Banana Shire Council

Alternate Route Options for Gibihi Road

Summary - Review of Alternate Design Options

Rev 1 September 2018

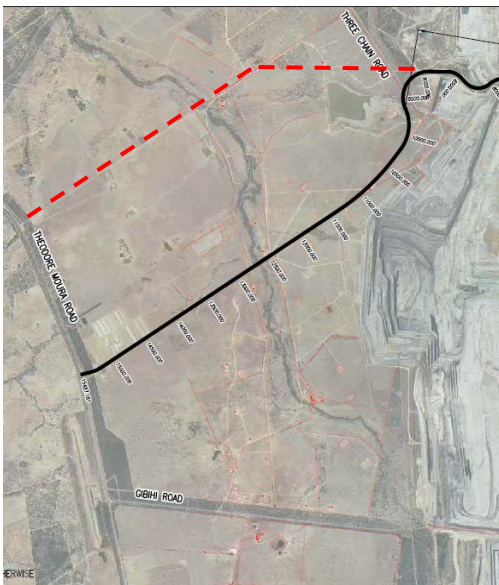
The alignment crosses a significant portion of gas well infrastructure under the control of WestSide and is in close proximity to a compressor station. WestSide was contacted to seek advice with respect to the protection requirements for their mains. WestSide have responded to Anglo with a feasibility level estimate of the risks and costs to enable the route to pass through their gas field. In summary, WestSide have indicated the following issues:

1. A 100km/h road running close to gas lines presents a high risk to the gas lines.
2. Cost of relocating gas lines and wells, lost production, etc. estimated at \$15M
3. Potential for the need to relocate Hillview processing plant estimated at \$50M
4. Time delays are expected to undertake the works which are yet to be confirmed but could be 6-12 months.

This presents a significant risk to the feasibility and timeline to deliver the project.

Figure 2 Concept Plan Dawson Highway Intersection

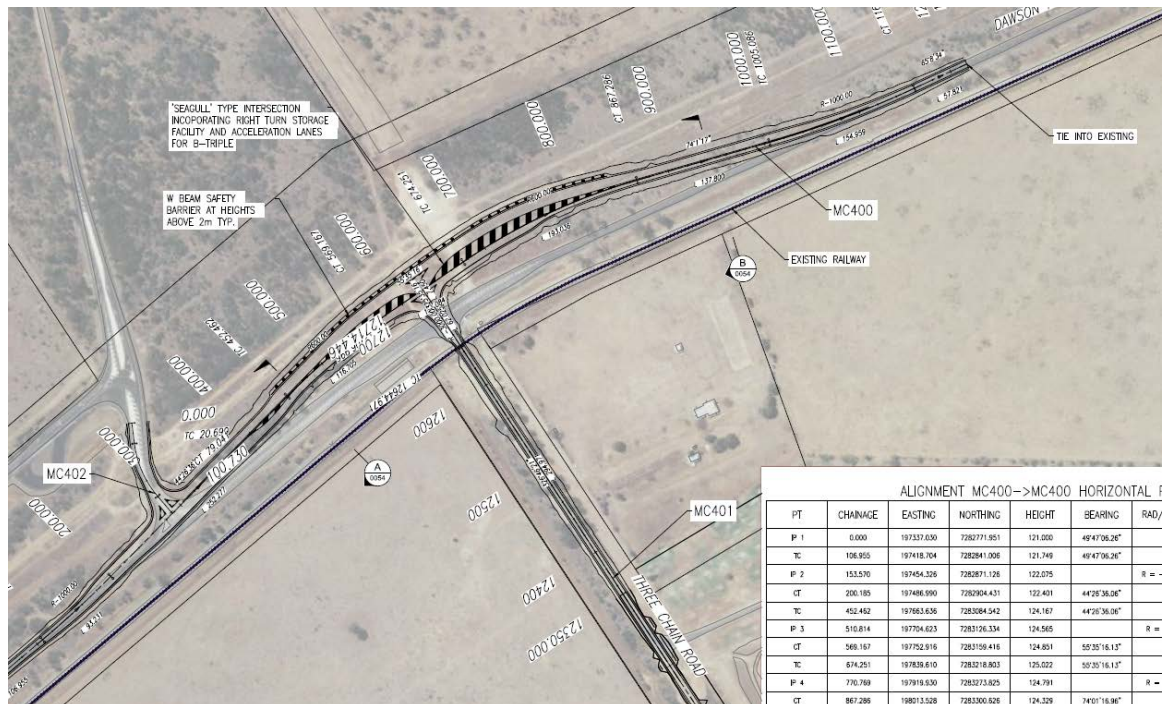
The current Dawson Highway Three Chain Road intersection is a Channelised intersection with auxiliary lanes for the right and left turns into Three Chain Road. The key issue with the current intersection is that the distance between the hold line at the stop sign in Three Chain Road to the rail level crossing is only 12.5 m, which means the trailer of trucks queued at the intersection are parked across the rail lines with nowhere to go if a train happens along. This is known as short stacking.

The type of intersection proposed by Hatch on behalf of Anglo is a Seagull pattern intersection as indicated in Figure 2. This is similar to the current intersection, only that the vehicles turning right out of Three Chain Road have their own lane on the Dawson Highway and have to merge with the through traffic once up to speed. This is the safest type of intersection for an un-signalised intersection, as it removes the 90 degree side impact from the left side for vehicles turning right out of Three Chain Road.

The Hatch concept plan on drawing set prefixed H357151-00000-223-292 has been sent to TMR for initial review and initial verbal comments.
